Agenda

Regular Board Meeting

**Re: American Heartland Bank  
Sugar Grove, Illinois  
Final Site Improvement Plans – 1<sup>st</sup> Review**

**TO:** VILLAGE PRESIDENT & BOARD OF TRUSTEES  
**FROM:** RICH YOUNG, COMMUNITY DEVELOPMENT DIRECTOR  
MIKE FERENCAK, VILLAGE PLANNER  
**SUBJECT:** DISCUSSION: REQUESTS FOR PRELIMINARY / FINAL PUD, SPECIAL USE, PRELIMINARY / FINAL PLAT, AND MAJOR PUD AMENDMENT FOR A PROPOSED BANK WITH DRIVE-THROUGH IN THE B-3 REGIONAL BUSINESS DISTRICT AT THE SW CORNER OF STATE ROUTE 47 & WHEELER AVENUE  
**AGENDA:** OCTOBER 16, 2012 COMMITTEE OF THE WHOLE MEETING  
**DATE:** OCTOBER 12, 2012

**GRADING PLAN**

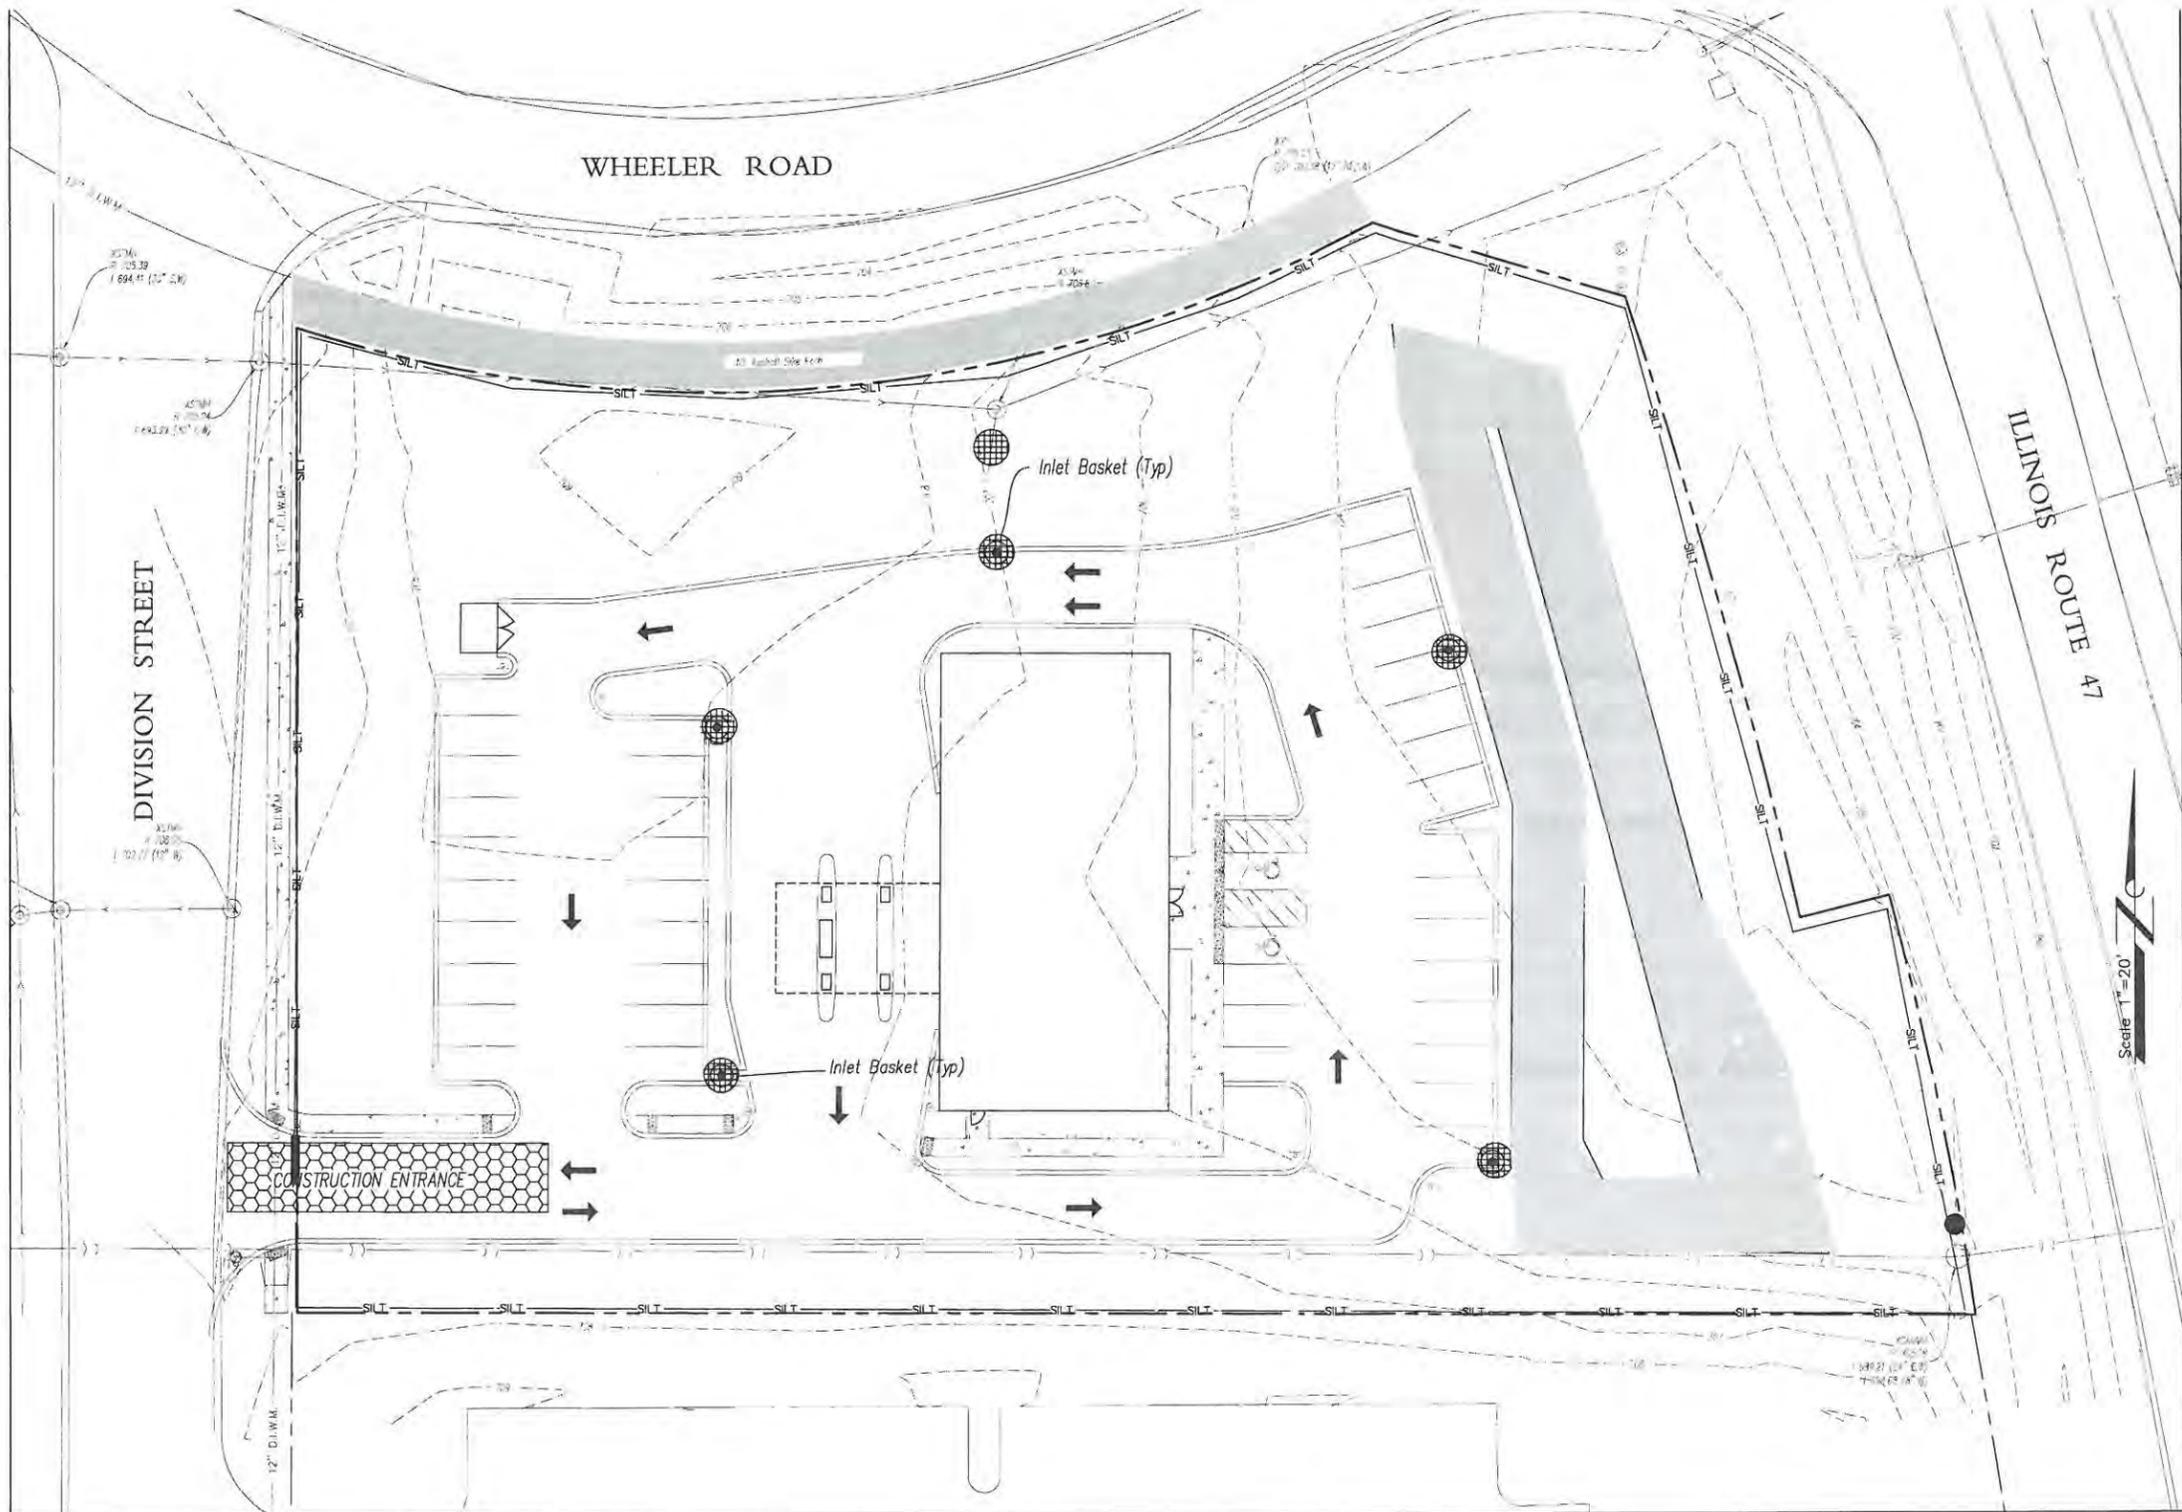
9. The maximum slope on site is 4:1. The slopes of the berms shall be revised accordingly.
10. We will defer to the Village staff regarding the following:

- ii. The long island in the west parking lot is only 3' in width.
  - c. Adequacy of the water service size and confirming the engineering and building plans correspond. (We did not receive plans for the building at this time.)

- d. Parking space requirements
  - e. Photometric Plan review
    - i. We recommend, at a minimum, the routing of the streetlight wiring be shown on the drawings.

11. There is an existing swale along the east property line. This swale shall be maintained accordingly. Under the proposed plan, the southeast portion of the site particularly appears to be very flat.

12. In regard to the parking lot grading, please note the following:
  - a. At least 1' shall be provided between the top of foundation and all pop points in the subdivision. Currently, the overland flow route exits the site at Division Drive at 707.0 and the top of foundation is at 707.6'. The grading plan shall be revised accordingly.

- b. The curb to the east of storm structure A-2 (Rim = 706.1) is greater than 13%. The grading in the vicinity shall be revised to minimize this drastic slope.
  - c. We recommend a maximum slope in the parking lot of 4%. This is exceeded in the area just south of the ADA parking stalls. The grading at this location shall be revised accordingly.
13. Grading consideration shall be given to the monument sign location, and the grading plan shall be revised accordingly.
14. An ADA ramp shall be installed at the southeast corner of Division Drive and Wheeler Road.
15. The bike path along Wheeler Road shall continue to the IDOT right of way at a minimum. (The limits of the IDOT right of way shall be shown accordingly.)

1 SITE LIGHTING PHOTOMETRIC PLAN  
SCALE 1" = 20'

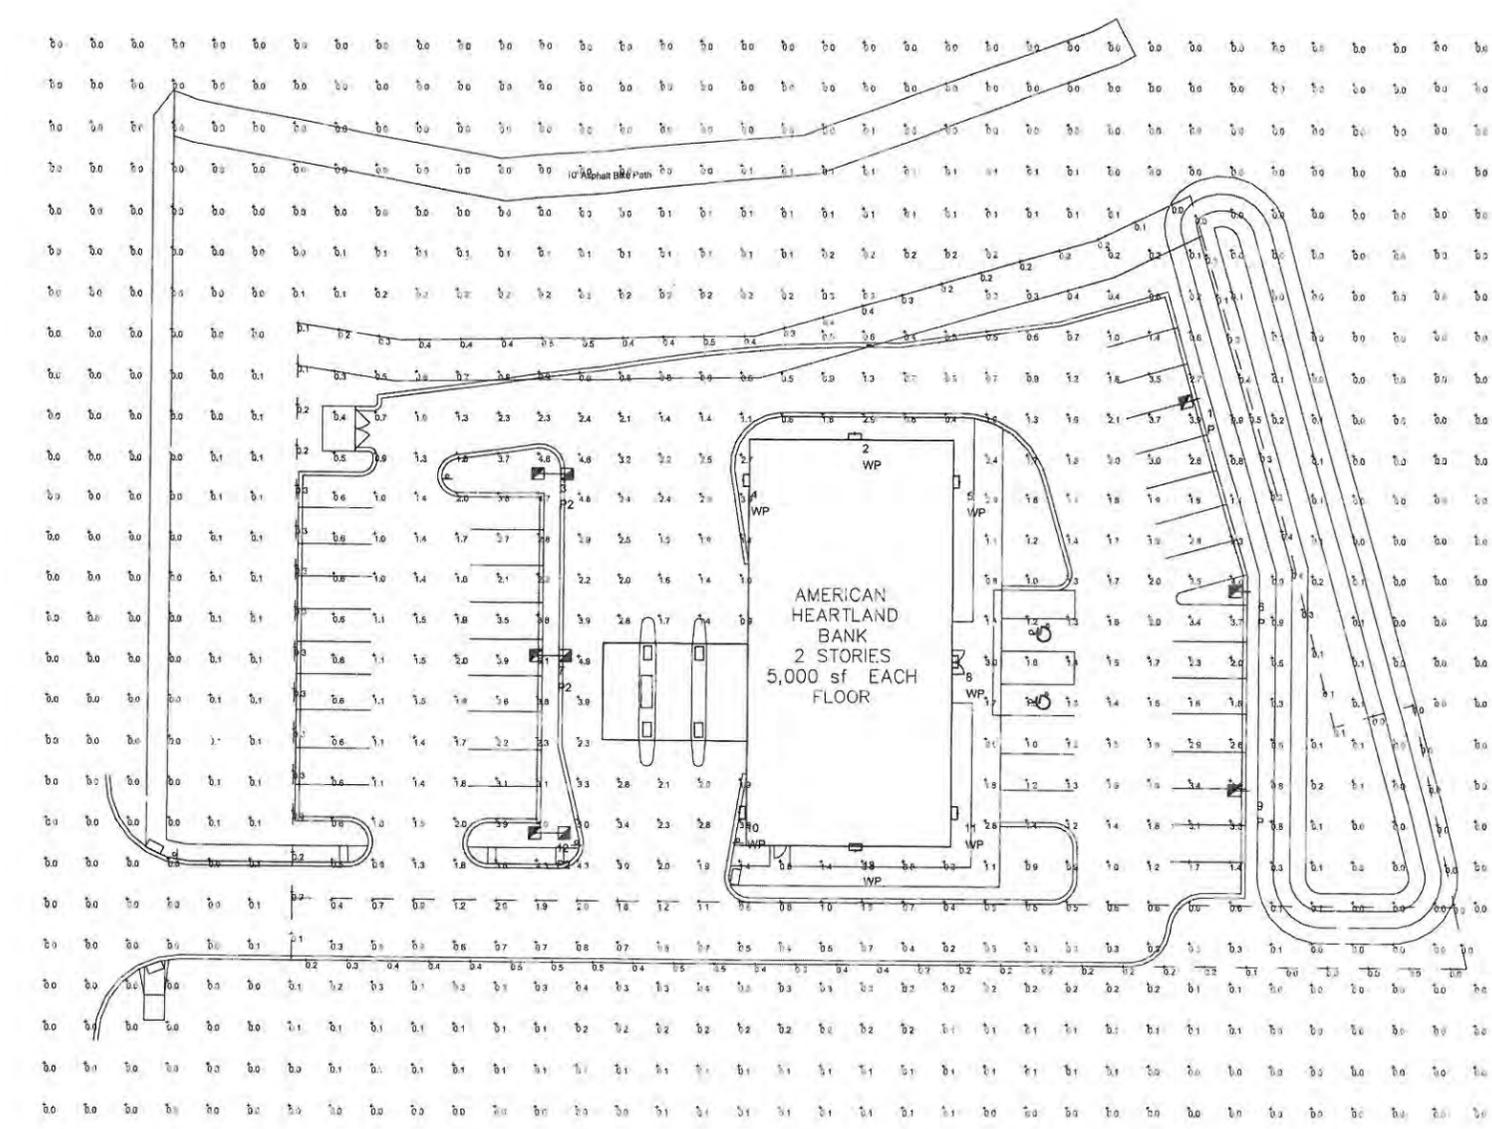
- a) The Photometric Plan is in compliance with the Zoning Ordinance requirements.
  - b) The 2004 PUD contains different average and maximum foot candle requirements that will be updated to the current Zoning Ordinance requirement.

- c) The pulse-start metal halide lighting proposed is ok.
  - d) The proposed parking lot lighting meets standard average foot candle (1.0-3.0), maximum foot candle at hotspot (10.0), and maximum foot candle at the property line (0.5) requirements. The proposed plan is showing (1.78), (5.1), and (0.5).

- f) All lights would be shielded to direct the light down to the ground.
- 7) Trash.**
- a) As mentioned above, the request is to not approve a Preliminary or Final Architectural Elevation Plan at this time, so no review has been provided at this time.

**DOUBLE-FACED ILLUMINATED SIGN**

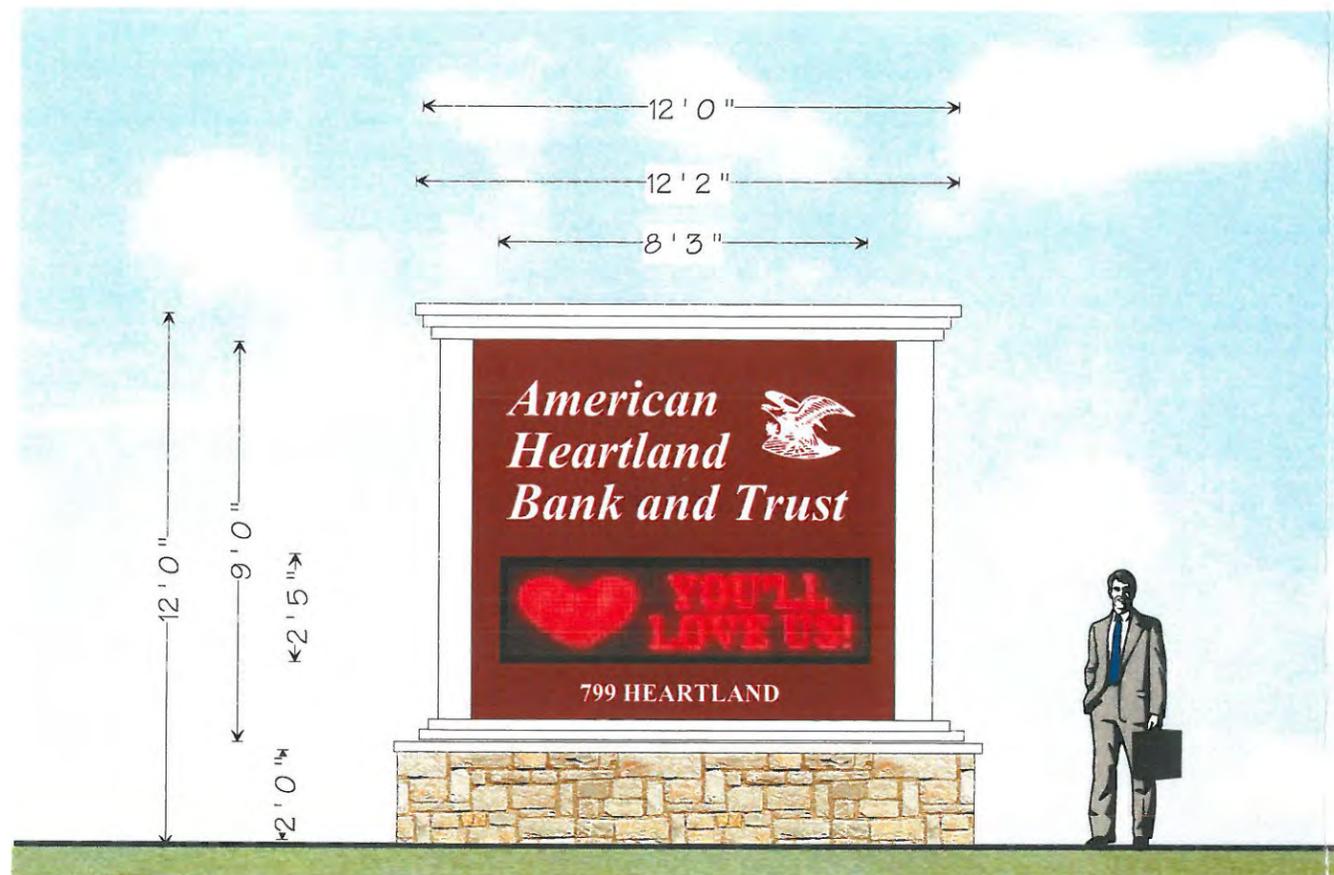
- c) The ground sign should be shown to scale and with the setback dimensioned on the Site Plan. The required setback is 1' for every 1' in height. The exception list includes an exception to Section 11-14-5-A-2 to allow for a setback of 18".

27. The Seed Mix and pond landscaping will need to be reviewed by the Village's consultant.
28. The Ground Sign Plan shall be revised to show a sign meeting all Zoning Ordinance requirements including setback, size, EMC sign type, EMC display area, EMC brightness and color, and EMC effects, but not including the setback required from residential-zoned areas.
